DOCUMENT CHANGE REQUEST

DCR number 339 Changes required for: General

Title: Resistors Fixed Chip Thick Film Based on Type CHP

Number: 4001/026

Page 7 Table 1(a)

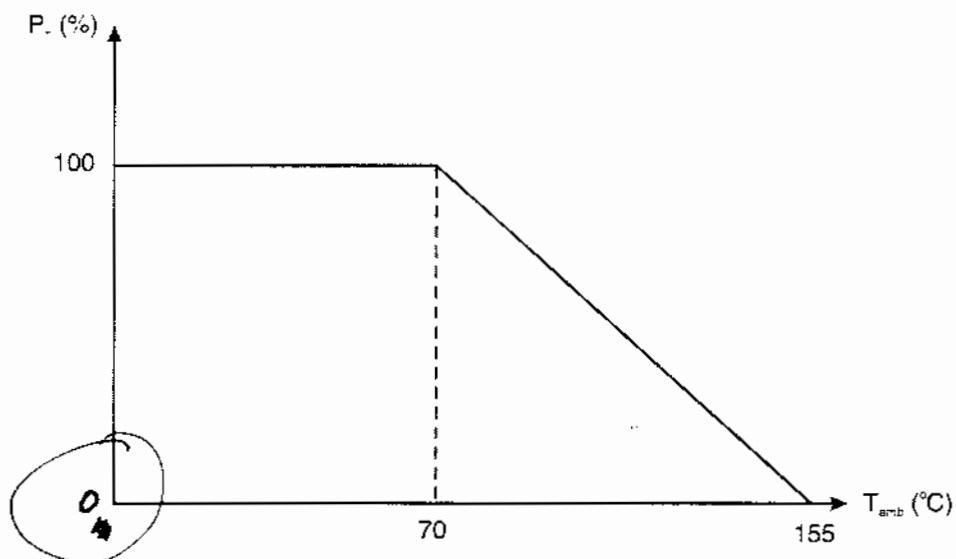
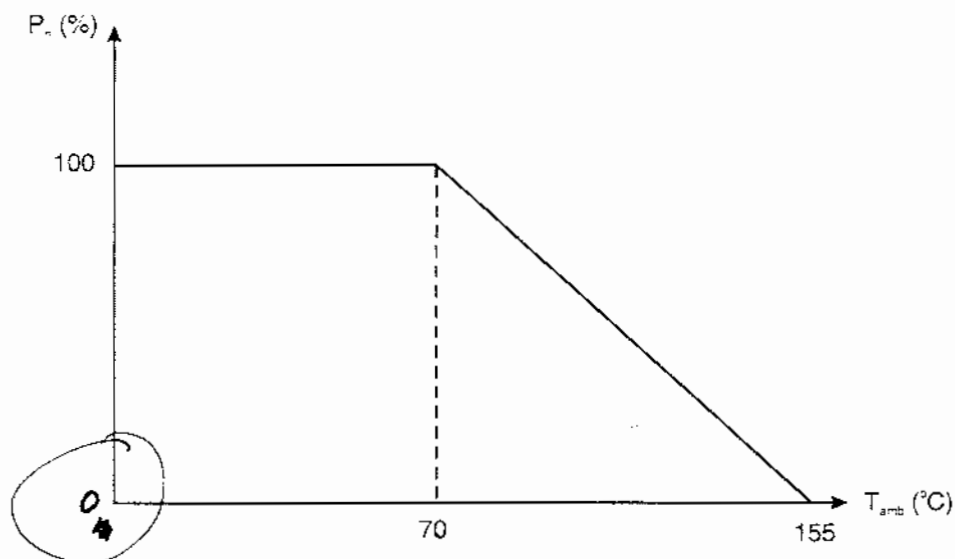
For Variant 05 correct the Critical Resistance value to be "112.5kohm" (was "112kohm")

Table 1(b) - MAXIMUM RATINGS

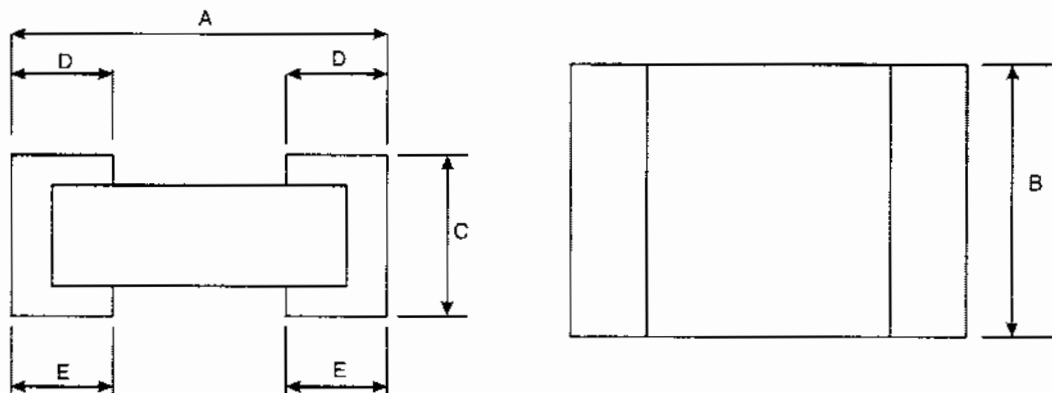
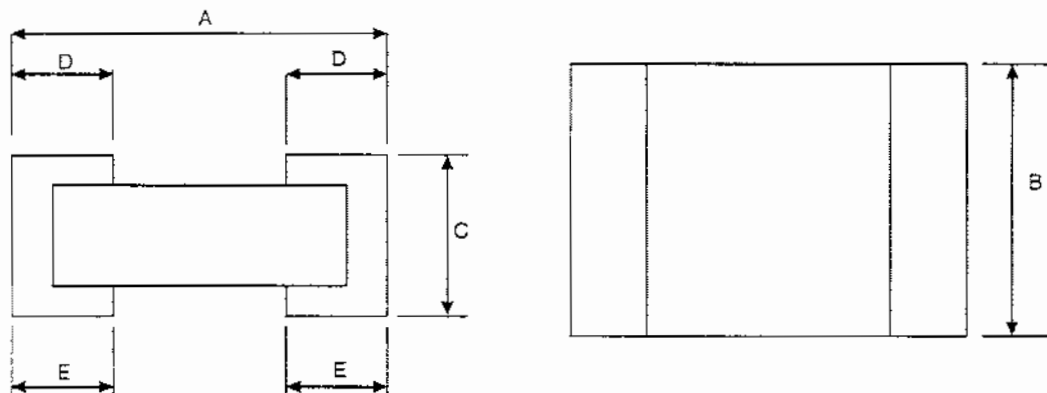
For Rated dissipation:

- correct Variant 03 style to be "1206" (was "1216")
- correct the Maximum ratings Units to be in "mW" (was in "W") e.g. Variant 01 to be "100mW" (was "0.1W")

For Insulation Voltage amend the symbol to be "UI" (was "Ui")
